P 538072

Septic Repair ON-SITE SEWAGE DISPOSAL SYSTEM HOWARD COUNTY HEALTH DEPARTMENT BUREAU OF ENVIRONMENTAL HEALTH

ADDRESS: 11476 Old Frederick Road PROPERTY OWNER: Stuart Blum

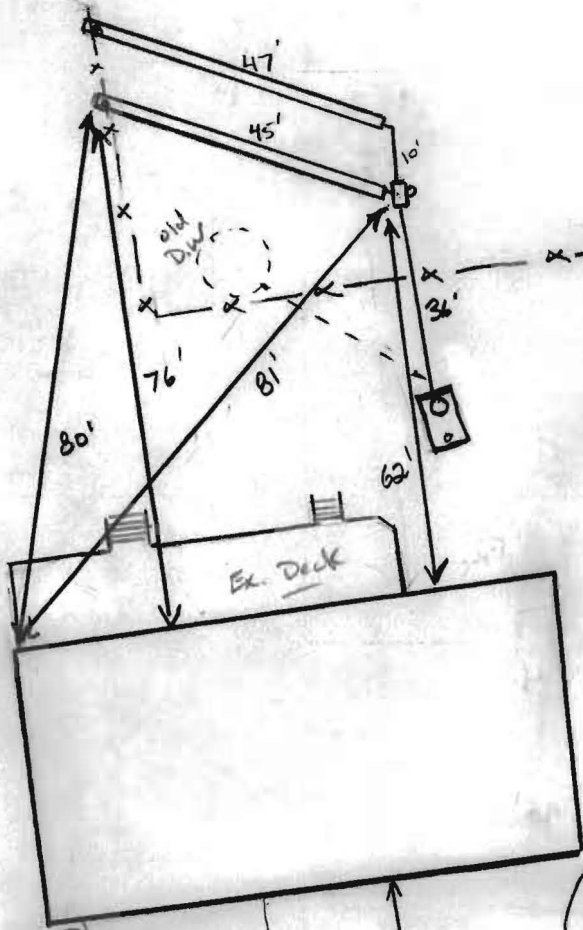
↑ Ex Bar (Does Have H₂O from Public H₂O)

10/17/12 Install new Dbox ~ 20' or so straight out from Ex S.T.
 Run 2x 45' trenches on contour across yard towards side fence
 running NW. Pump and collapse ex. Dry well. Manhole riser and new
 out let baffle must be installed on tank (P)

10/18/12 system complete. OK to cover. Dbox tested.
 Ex. DW pumped and collapsed. Ex. well on pump still connected and
 in use by Front yard spicket only. Everything else on public H₂O.
